Service Manual

CD Stereo System

SA-AK230E / SA-AK230EB / SA-AK230EG

Top Cabinet change (Additional Information)

2.1. Cabinet Parts Location (Additional Information)

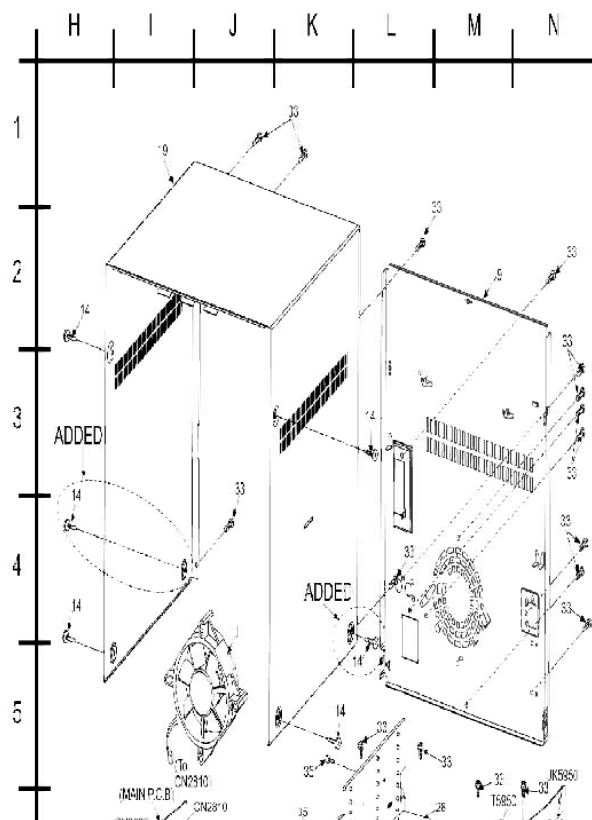
During the replacement of the top cabinet for the mentioned models, the below rules of compatibility (Table 1) must be followed & parts must be replaced correctly. This is mainly due to top cabinet specification change (additional of one screw hole) for improvements.

- When replacing the new top cabinet, ensure that the NEW bottom

chassis must also be changed together at the same time (Refer to Table 1).

- Do not interchange the parts.

With reference to page 98 (section 23.3.1) of the original service manual for SA-AK230E/EB/EG-S. The cabinet parts location below is for the new implementation.

Ref. No.	Part No.	Part Name & Description	Remarks
		CABINET AND CHASSIS	
19	RKMX0105-S1	TOP CABINET	[M]
